Damaged Wiring Harness – Possible Intermittent Engine Misfire/No Start – Remove Harness Clip

MODEL 1995-96 MY
Sedan Range
VIN
720001-770946

ILLUSTRATION 1

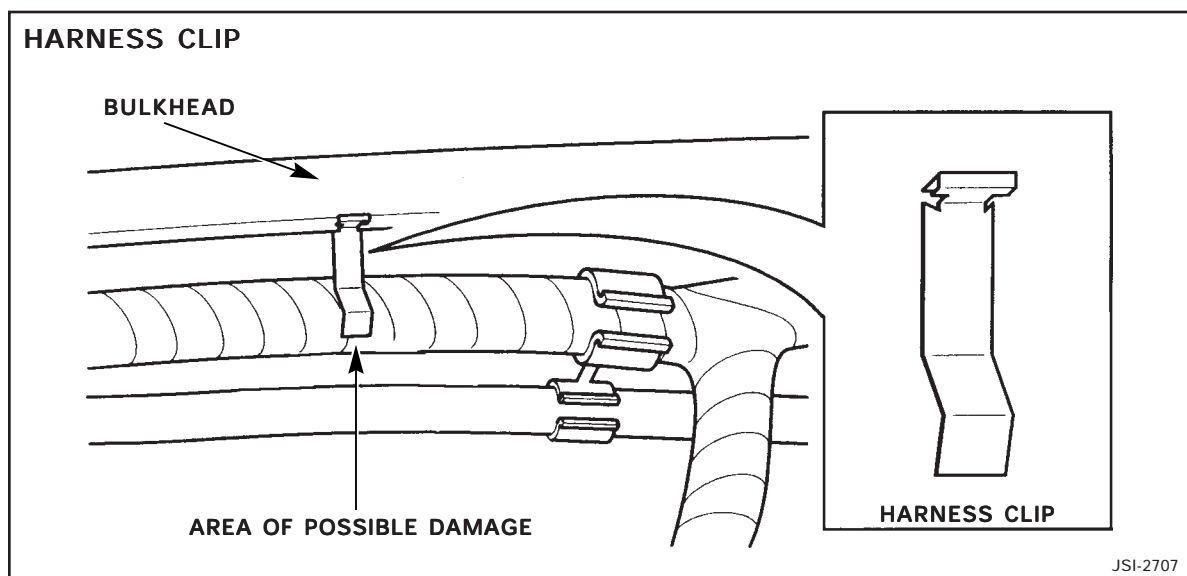
Some Sedan Range vehicles within the above VIN range may exhibit a condition of engine misfire/no start, which can be caused by a clip shorting the engine management harness to ground. The clip, which is located on the bulkhead on the right side of the engine compartment (Illustration 1), may cut into the harness causing a short circuit.

The clip is not found in this location on all vehicles and was deleted from the vehicle build specification after VIN 770946.

Remove and discard the clip on all vehicles where it is found, to eliminate the possibility of it penetrating the harness.

In case of a customer complaint of engine misfire/no start, check if the clip is present and if it has penetrated the harness. Remove and discard the clip. Test to verify if the harness has been damaged and repair as needed.
